# UNITED STATES PATENT AND TRADEMARK OFFICE

APPLICATION NO.	FILING DATE	FIRST NAMED INVENTOR	ATTORNEY DOCKET NO.	CONFIRMATION NO.
09/970,104	10/03/2001	Motohiro Suzuki	SIW-013	1403

**Office Action Summary**

## **DETAILED ACTION**

The APA'277 teaches a conventional humidifier utilizing a hollow fiber membrane module as follows (SECTION 0003-0006/ Figure 23):

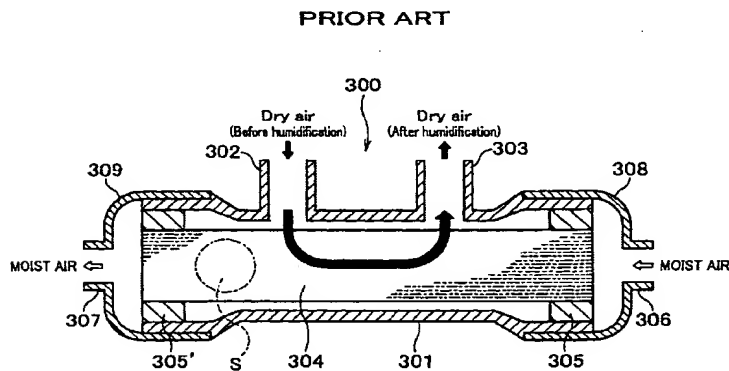
10. Claims 1 and 5 are rejected under 35 U.S.C. 102(b) as being anticipated by applicant's admitted prior art in the US application 09/764277 (*herein after referred to as APA'277*).

[0003] A conventional humidifier utilizing hollow fiber membranes is disclosed in Japanese Laid-open Patent Publication No. HEI-7-71795. As shown in FIG. 23, a humidifier 300 comprises a housing 301, on which is provided a first inlet 302 for introducing dry air and a first outlet 303 for discharging the dry air (humidified dry air). A bundle of hollow fiber membranes 304 consisting of a number of for example 5000 hollow fiber membranes is accommodated within the housing 301.

As to the specific preamble reciting “for a fuel cell system” and “reactive gas and off-gas flow relationship”, it is pointed out that the preamble and limitations refer to intended use. That is, the claim is directed to “a humidifier” per se and the preamble phrase “for a fuel cell” is only a statement of ultimate intended utility.

Further, given that no specific fuel cell structure has been positively claimed, it is also contended that the recited flow relationship of both the reactive gas and the off-gas is an ultimate utility. Thus, since the APA’277 does encompass flowing gases each having a different moisture content inside and outside the hollow fiber membrane, it is contended that the APA’277 satisfies the requirement of having both gases i.e. the reactive gas and the off-gas themselves.

It is also noted that the examiner has interpreted that “the liquid exhaust mechanism which exhausts liquid” can be the same “reactive gas exit” itself or “the off-gas exit” as such,

*because they are able to exhaust liquid which has been generated therethrough. In that, the "reactive gas exit" and/ or "the off-gas exit" are inherently recited by the claim because gas entrances and exits are necessarily required in order to supply and remove the gas from the humidifying unit.*

Thus, claims 1 and 5 are anticipated.
